SUBJECT: Forwards response to NRC 810608 request for addl. info re: auxiliary feedwater automatic initiation & flow indication. Preliminary diagrams provided.

Re: Turkey Point Units 3 & 4  
Docket Nos. 50-250 & 50-251  
Auxiliary Feedwater Automatic  
Initiation and Flow Indication

REQUEST FOR ADDITIONAL INFORMATION

TURKEY POINT UNITS 3 & 4 AUXILIARY FEEDWATER (AFW)

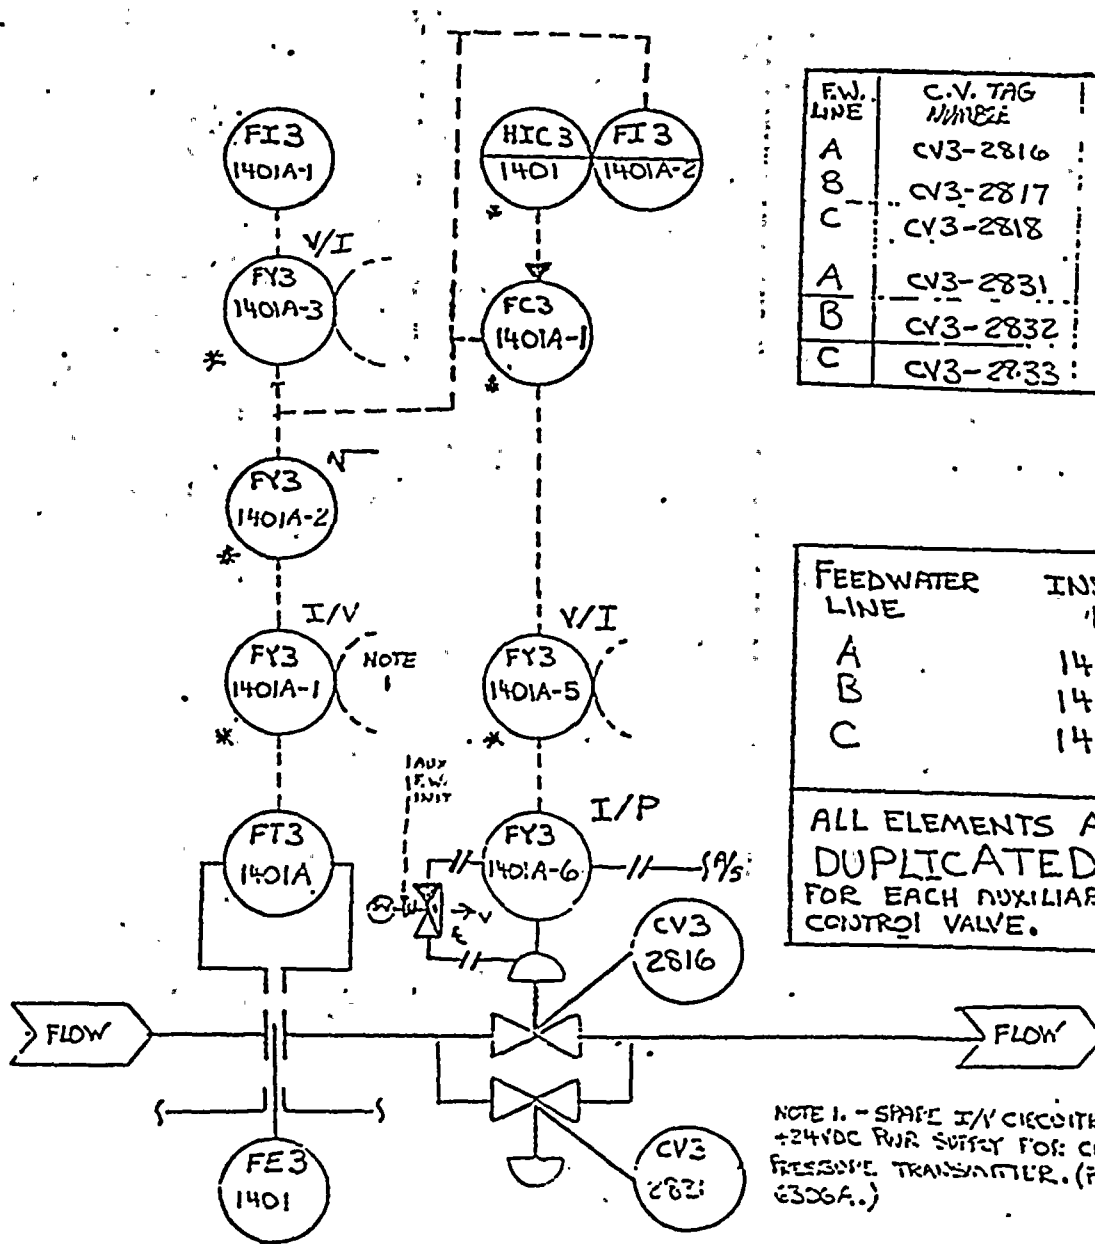
Which of these alternatives has been selected? Provide the new logic and electric schematic diagrams for these valves. If alternative 2 is selected, describe the periodic surveillance planned to provide the operator positive assurance that these valves are in their proper positions.

Alternative 1, with slight modifications, has been selected. For a description of the system, see Enclosure 3 of FPL letter L-81-36, dated February 3, 1981, to Mr. Darrell Eisenhut. Preliminary, new logic and electrical schematic diagrams are attached to this letter, as follows:

- 5177-109-J305-16, Preliminary Block Diagram  
AFW Flow Control
- 5177-109-J305-17, Preliminary Block Diagram  
AFW Flow Control
- 5177-109-E-05 Sheets 1 and 2, Elementary  
Diagram AFW Flow Control and Indication
